Prairie Island Nuclear Generating Plant Unit 2  
Docket 50-306  
License No. DPR-60

Response to Request for Additional Information Regarding 10 CFR 50.55a  
Request for Relief from ASME Section XI Repair and Replacement  
Requirements: Proposed Alternatives for Application of Structural Weld Overlay  
to the Prairie Island Nuclear Generating Plant Unit 2 Pressurizer Surge Nozzle  
Weld (2-RR-4-8) (TAC MD5868)

**Enclosure 1**  
**Responses to Requests for Additional Information**  
**10 CFR 50.55a Request No. 2-RR-4-8, Rev. 1**

**Enclosure 2  
Prairie Island Nuclear Generating Plant Unit 2  
10 CFR 50.55a Request No. 2-RR-4-8, Rev. 1**

FIGURE 1  
PINGP UNIT 2 PRESSURIZER SURGE  
NOZZLE OVERLAY DIAGRAM

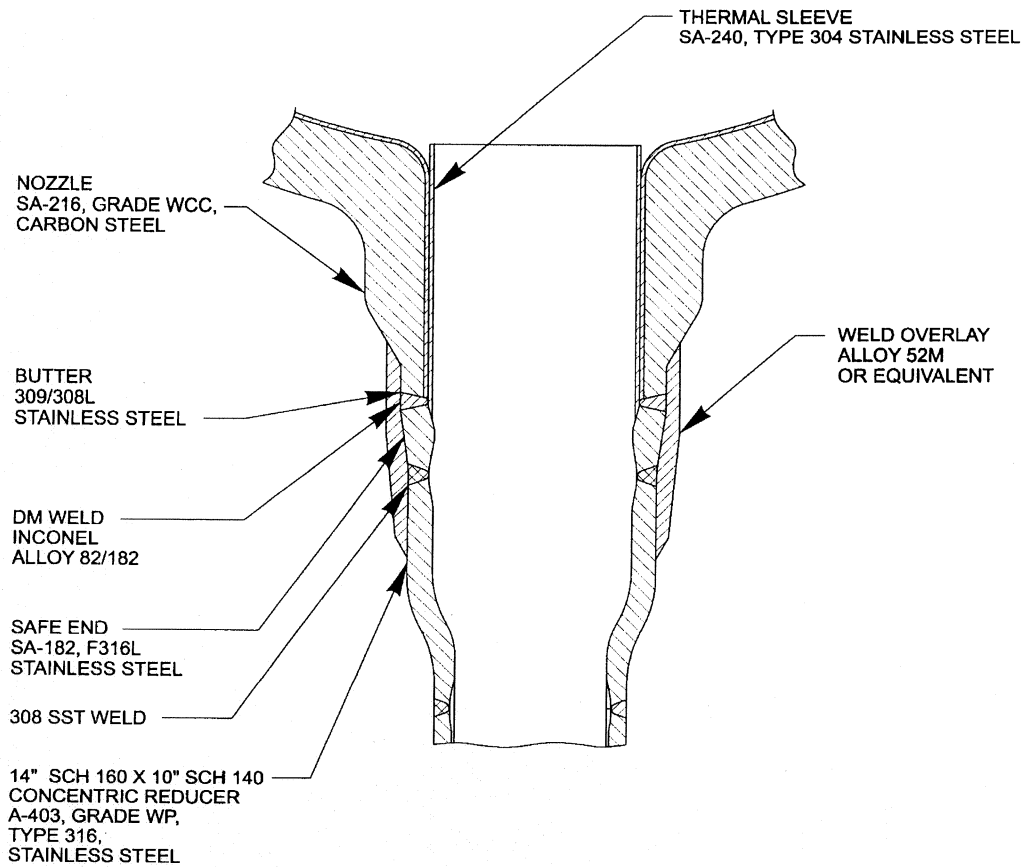
- 1.0 The U.S. Nuclear Regulatory Commission (NRC) understands that Alloy 82 material may be applied over the existing dissimilar metal weld, overlapping slightly onto the stainless steel safe end, and that E309L filler metal may be applied to the remaining stainless steel components. Please describe the sequence of welding when applying the barrier layer to prevent hot cracking. The NRC is concerned that if the correct sequence is not followed, cracking could occur when tying the E309L filler metal into the Alloy 82 material.**

The stainless steel ER309L layer will be deposited over the inboard portion of the stainless steel reducer, the reducer to pipe stainless steel weld, and over the stainless steel safe end to near the dissimilar metal weld. Alloy 82 will then be deposited over the nozzle terminal end stainless steel buttering, the Alloy 182 safe end to buttering dissimilar metal weld, and onto the inboard portion of the stainless steel safe end to tie in with the ER309L stainless steel layer.
